CHANGE/ERRATA INFORMATION

ISSUE NO: 4 4/85

Title: 1953A
Print Date: January 1975
Rev.- Date: 4-1/79

Figure 1.

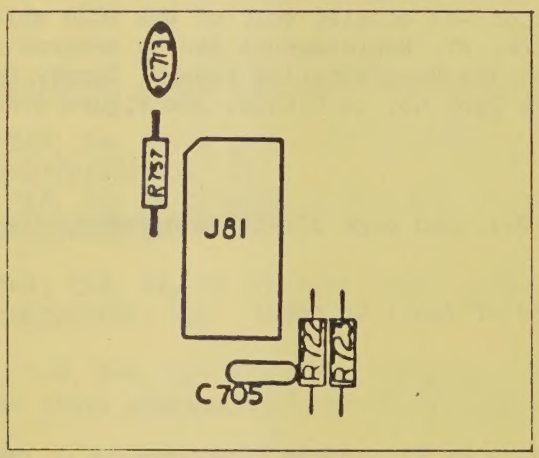
On pages 612-9 and 612-10, Table 612-5, make the following change:

ADD: C713| CAP, CER, 0.0012 UF ±10%, 500V| 106732| 71590| CF122| 1

CHANGE: R754,R756| RES. COMP, 100K ±5%, 1/4W | 148189| 01121

| CB1045 | 3

TO: R754,R756| RES. DEP. CAR. 100K ±5%, 1/4W| 348920| 80031

| CR251-4-5P100K| 3

CHANGE: R757| RES, COMP, 100K, ±5%, 1/4W| 148189| 01121

| CB1045 | REF

TO: R757| RES. CF. 10Ω ±5%, 1/4W | 340075| 80031|
CR251-4-5P10E| 1

On pages 612-11/612-12, and 8-38, Figures 612-5 and 8-15, add C713 and R757 as shown in Figure 1.

Figure 2.

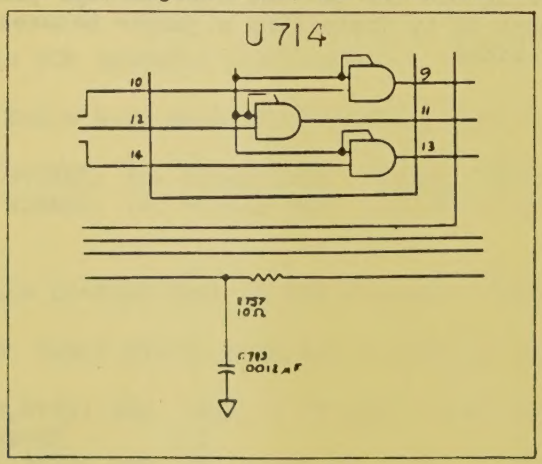
On page 8-40 (2 or 2), Figure 8-15, add C713 and R757 as shown in Figure 2.

Figure 3.

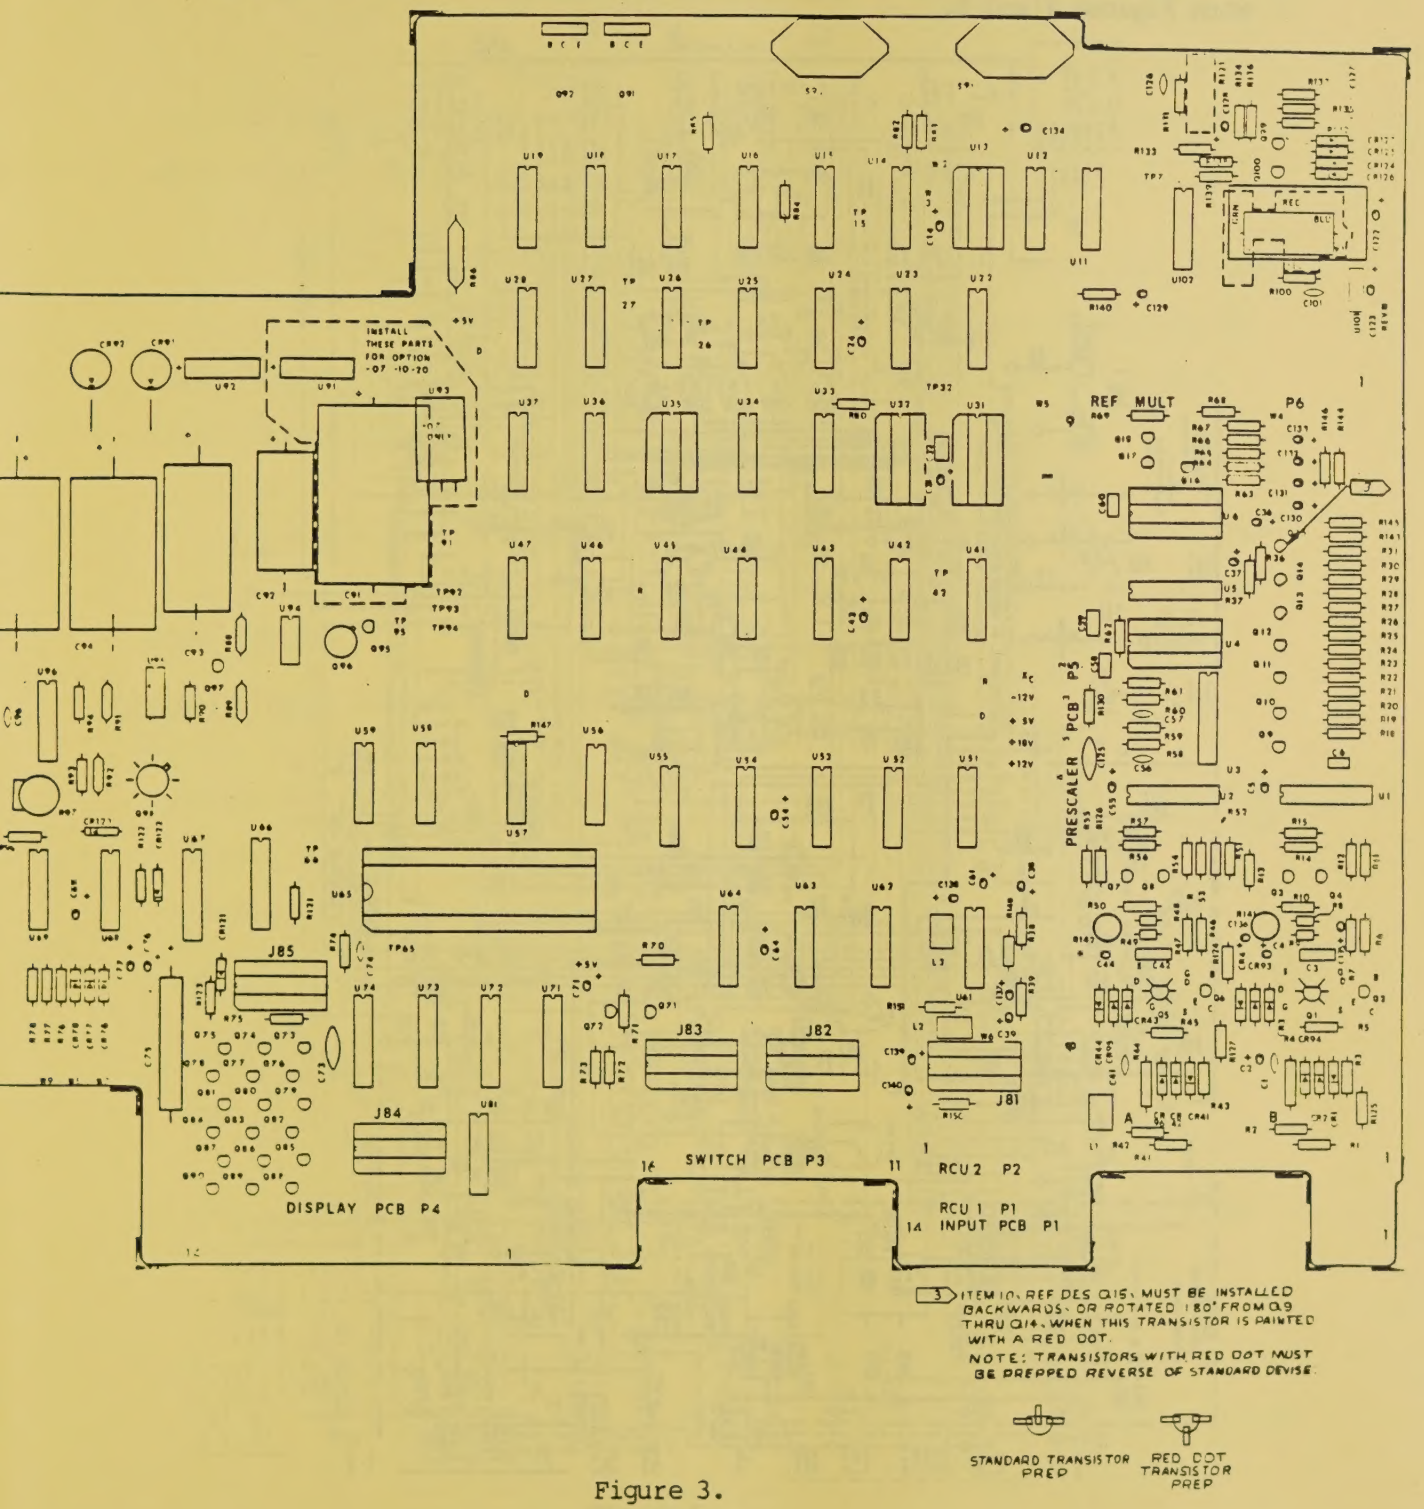
On pages 5-15, 8-4, 8-6, 8-7 and 8-13, Figures 5-3 and 8-2 (2 of 8 and 3 of 8), make the above changes as shown in Figures 3, 4, and 5 of this change/errata.

On pages 5-15, 8-4, 8-6 (2 of 8), and 8-13, Figures 5-3 and 8-2, make the above changes as shown in Figures 3 and 4 of this change/errata.

On pages 5-15, 8-4, 8-7 (3 of 8), and 8-13, Figures 5-3 and 8-2, make the above changes as shown on Figures 3 and 5 of this change/errata.

On pages 5-15, 8-4, 8-7 (3 of 8), and 8-13, Figures 5-3 and 8-2, make the above changes as shown on Figures 3 and 5 of this change/errata.

CHANGE: R96¦ RES. COMP 5.6K ±5%, 1/4W¦ 148080¦ 01121
¦ CB5625 ¦ REF
TO: R96¦ RES. CF 5.1K ±5%, 1/4W ¦ 573329¦ 80031
¦ CR251-4-5P5K1¦ 1

On pages 5-15, 8-4, and 8-13, replace Figures 5-3 and 8-2 with Figure 3.

Figure 4.

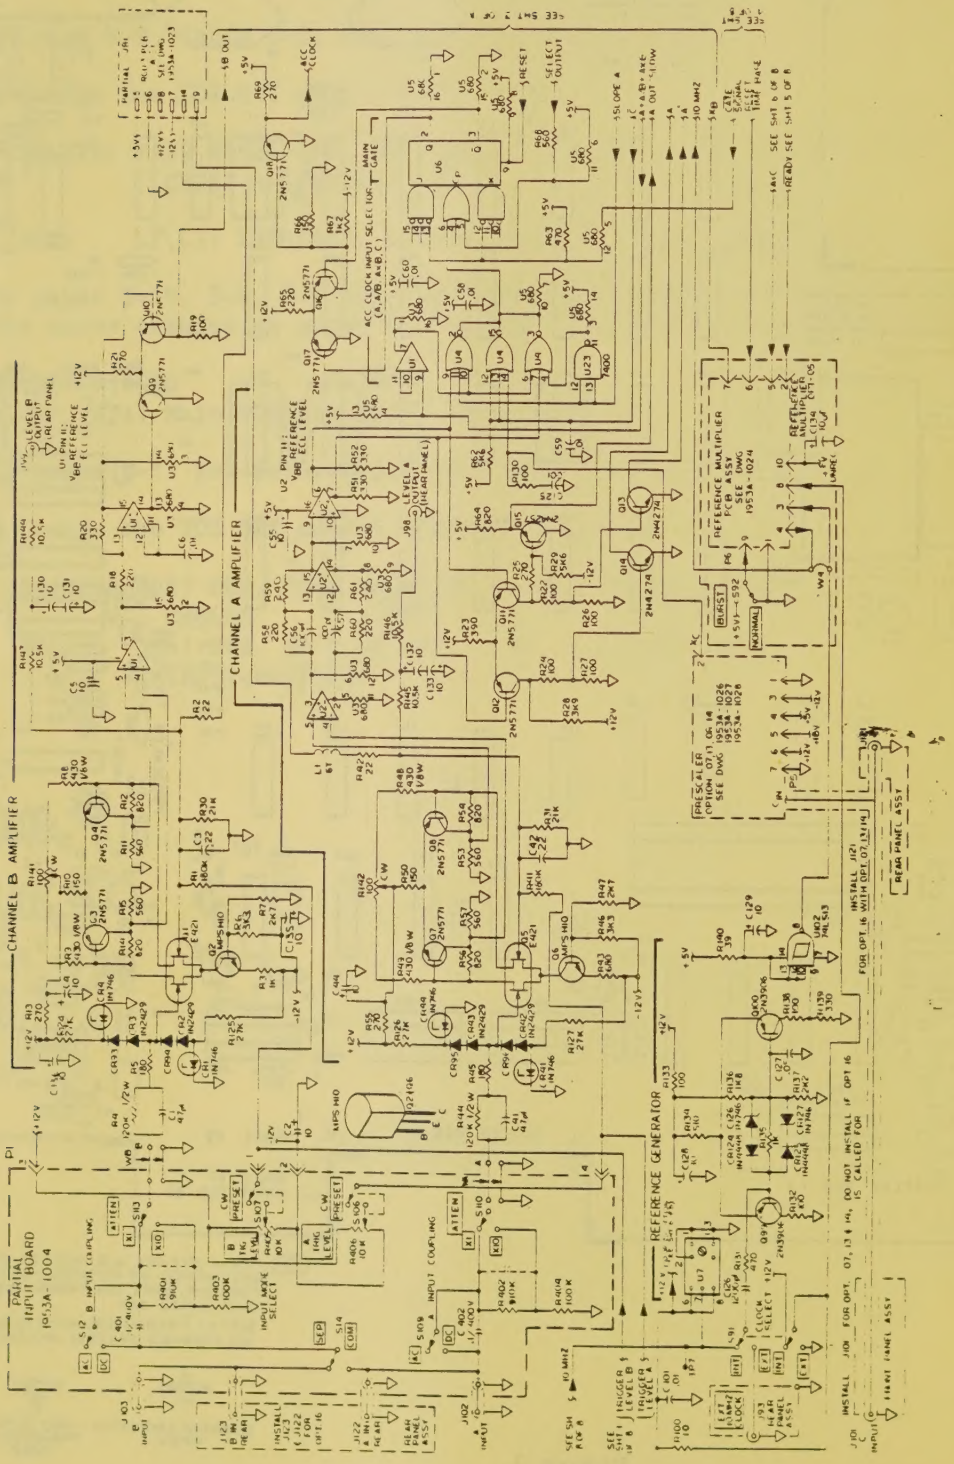
On pages 8-6 and 8-7, Figure 8-2, replace sheets (2 of 8 and 3 of 8) with Figures 4 and 5.

Figure 6.

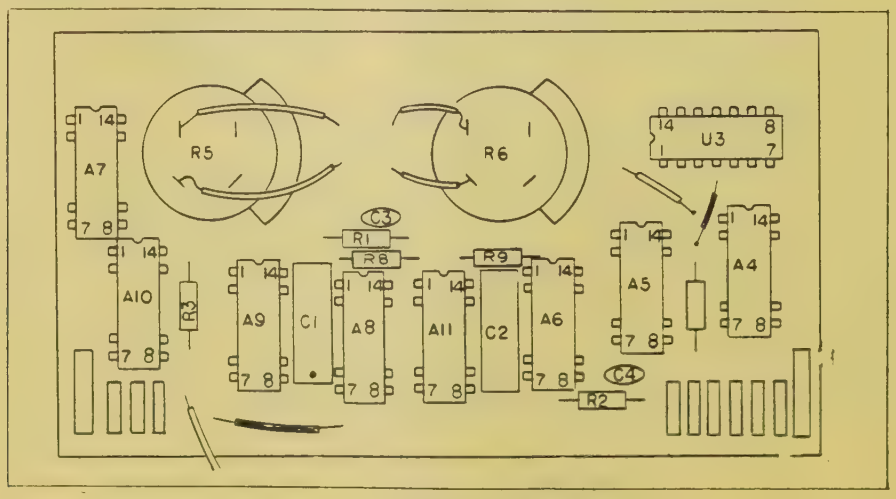
ADD: R8,R9| RES, CF, 1K, ±5%, 1/4W| 343426| 80031| CR251-4-5P1K| 2

On pages 612-8 and 8-36, Figures 612-4 and 8-14, add R8 and R9 as shown in Figure 6.

Figure 7.

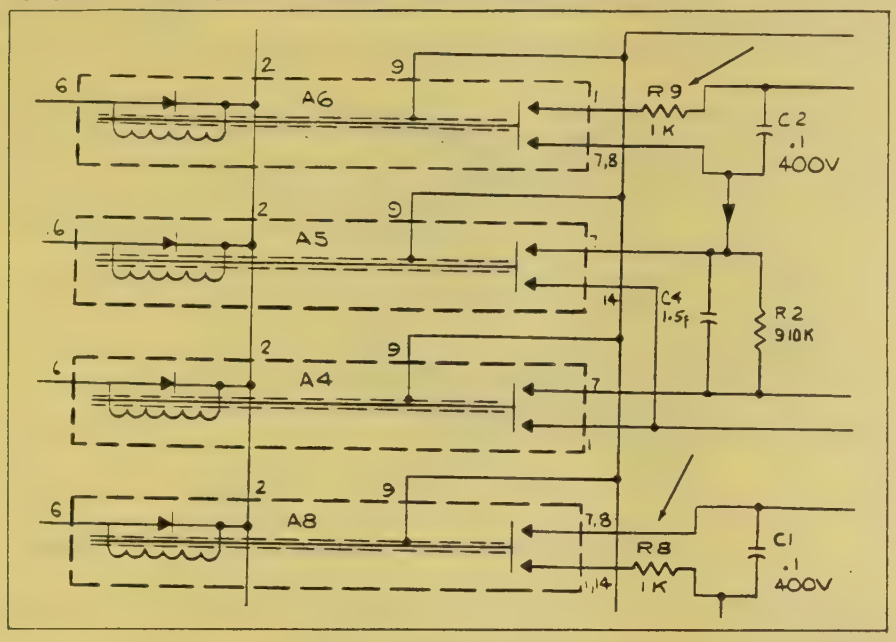
On page 8-37, Figure 8-14, add R8 and R9 as shown in Figure 7.

Figure 8.

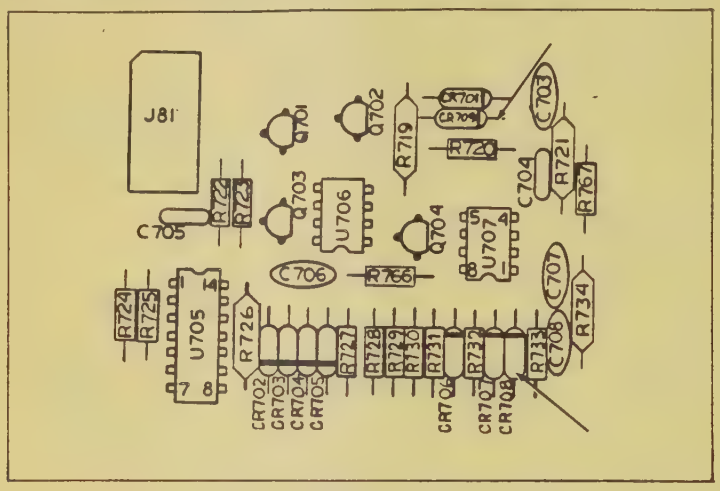
ADD: CR708,CR709| DIODE, ZENER, UNCOMP, 6.2V, 5%, 20.0MA, 1/4W| 325811

| 07910| 1N753A| REF| | 1

On pages 612-11/612-12, and 8-38, Figures 612-5 and 8-15, add CR708 and CR 709 as shown in Figure 8.

Figure 9.

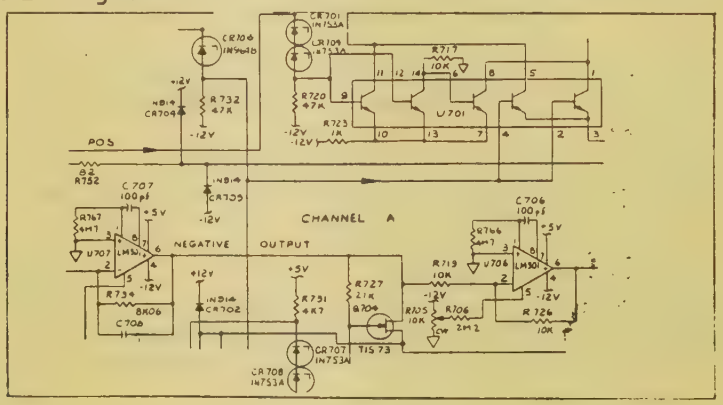
CHANGE: CR701| DIODE, ZENER, 12V, 400MW | 110726

| 07910| 1N964B| 3| | 1

TO: CR701| DIODE, ZENER, UNCOMP, 6.2V, 5%, 20.0MA, 1/4W| 325811

| 07910| 1N753A| 4| | 1

CHANGE: CR707| DIODE, ZENER, 12V, 400MW | 110726

| 07910| 1N964B| 3| | 1

TO: CR707| DIODE, ZENER, UNCOMP, 6.2V, 5%, 20.0MA, 1/4W| 325811

| 07910| 1N753A| 4| | 1

On page 8-39, Figure 8-15, make the changes listed on the previous page as shown in Figure 9.

Figure 10.

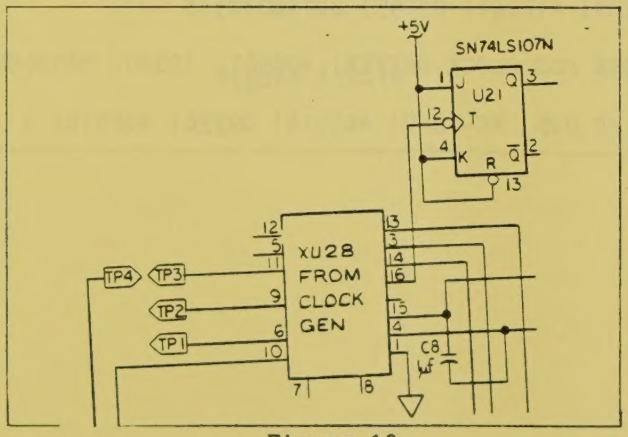
Change #13 documents the steps to be taken when replacing U28, P/N 404459, on the 1953A-4041 PCB assembly. When ordering a replacement for U28, order kit 1953A-7015K, P/N 762070. Installation instructions are included in the kit. Complete the following changes in your manual when you have received the replacement kit.

DELETE: C5¦ CAP, TA, 0.47 UF ±20%, 250V¦ 161349¦ 56289
¦ 196D474X0035HA1¦ 1

DELETE: C6,C7¦ CAP, MICA, 22 PF ±5%, 500V¦ 148551¦ 72136¦ DM15C220J¦ 2

DELETE: CR1¦ DIODE, SI¦ 203323¦ 07910¦ 1N4448¦ 3

DELETE: R1¦ RES, COMP, 51 ±5%, 1/4W¦ 221879¦ 01121¦ CB5105¦ 1

DELETE: R2¦ RES, COMP, 680K ±5%, 1/4W¦ 188433¦ 01121¦ CB6845¦ 1

CHANGE: U28¦ IC, CLOCK GENERATOR, MICRO-COMPUTER SET¦ 404459¦ 34649
¦ C4201 ¦ 1¦ 1
TO: U28¦ IC, CLOCK GENERATOR PCB ASSY TESTED ¦ 752279¦ 89356
¦ 752279¦ 1¦ 1

DELETE: Y1¦ CRYSTAL, 5.185 MHZ, ±0.02%, HC-18/U¦ 408518¦ 89536
¦ 408518¦ 1

On page 8-33, Figure 8-12, make the changes previously listed as shown in Figure 10.

Figure 615-10.

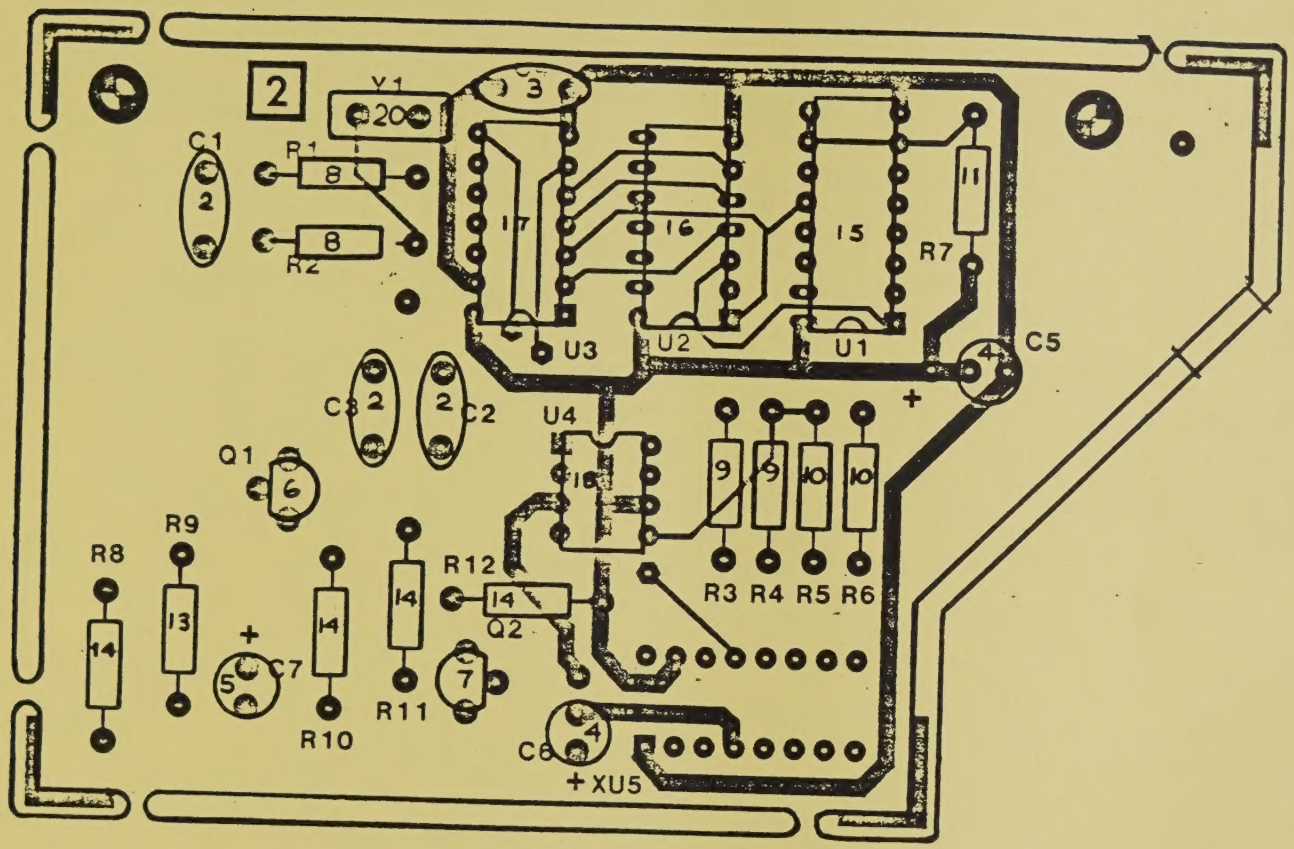
On page 615-16, add Table 615-13a., Figures 615-10 and 615-11.
